**Lincoln Heights Community Response to
“Draft Site Characterization Report and Removal Action Workplan - Avenue 34”**

October 28, 2021

Avenue 34 characterization, showing no concentric contamination flow models, or impacts to surrounding properties.

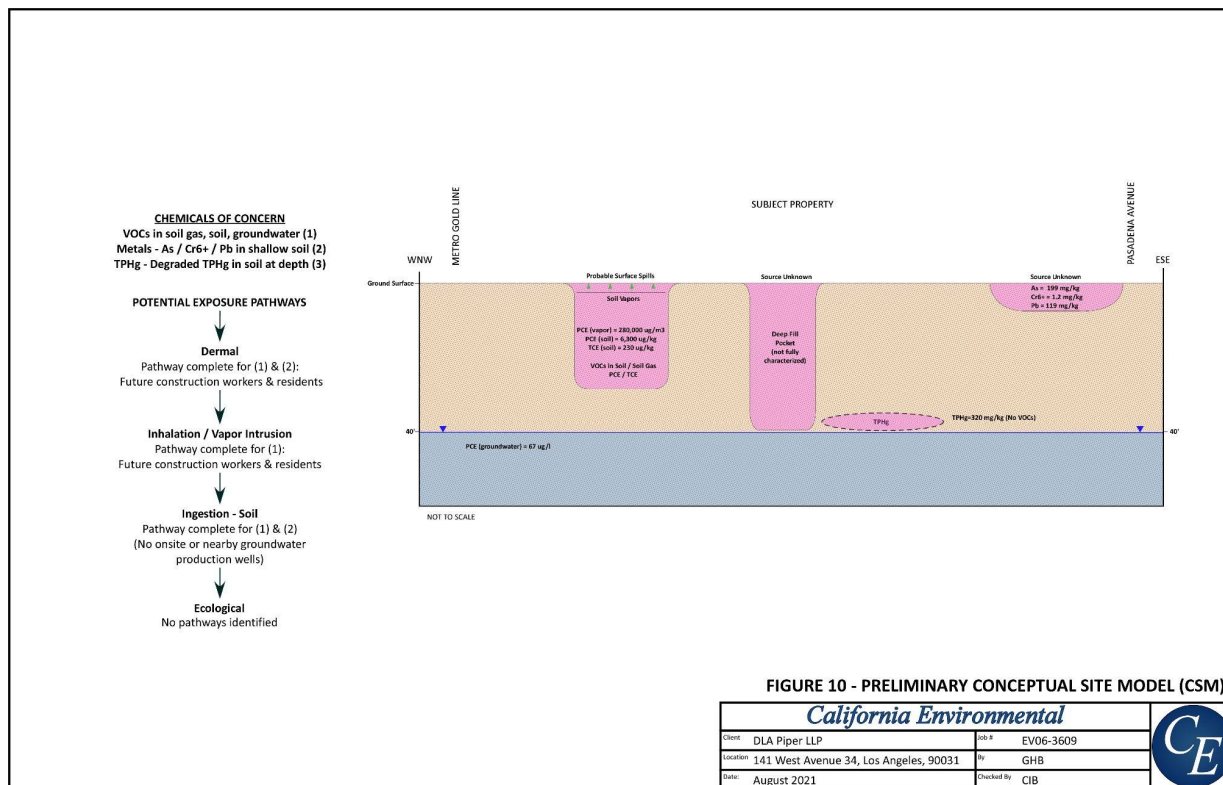
17. Page 16, Section 4.0 - A conceptual site model should include sources, concentration gradients, and movements of contaminated liquids and vapors. The consultants should prepare a dynamic model including sources, pathways, and discharges, along with vapor movements around and through barriers and preferential pathways. This model should be completed before an appropriate remedy is considered.
